**AMENDMENTS TO THE DRAWINGS**

**REMARKS/ARGUMENTS**

ZHANG et al.  
Appl. No. 10/813,131  
January 24, 2006

Fig. 2 (PRIOR ART)

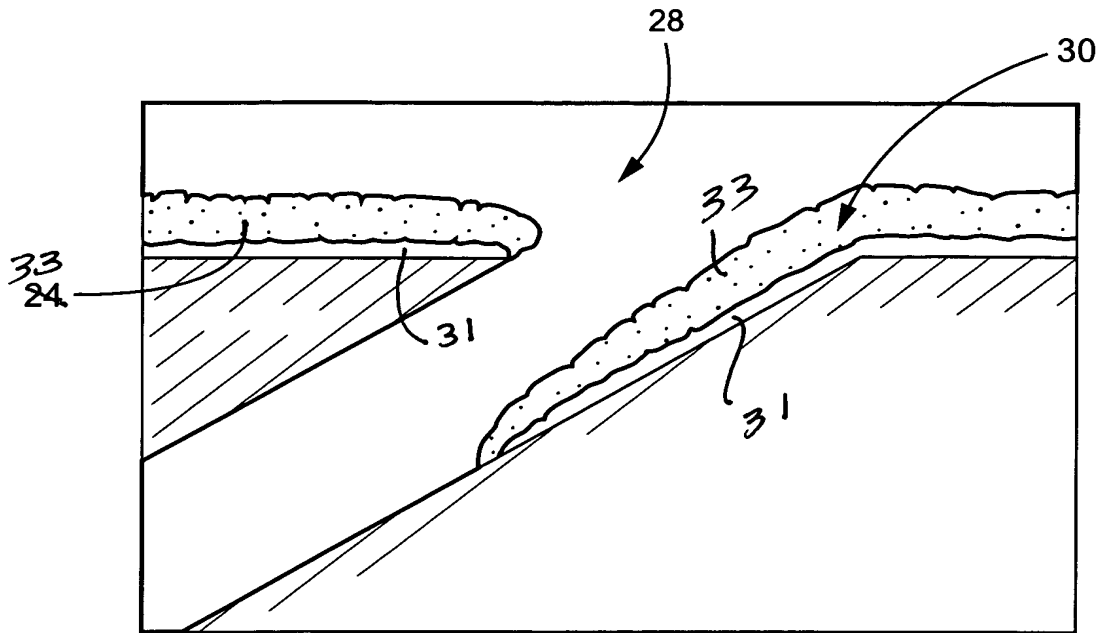
The attached sheet of drawings includes changes to Figs. 2 and 3. The sheet replaces the original sheet 2 of the drawings as filed.

The Examiner has objected to the drawings for failing to disclose both the first bond coat layer and second bond coat layer as called for in claims 4-6, 9 and 10-12.

Applicants have submitted herewith a new sheet 2 incorporating amended Figures 2 and 3 with reference numerals indicating both the bond coat and ceramic top coat in Figure 2. In addition, Figure 2 has been labeled, "Prior Art" as required by the Examiner.
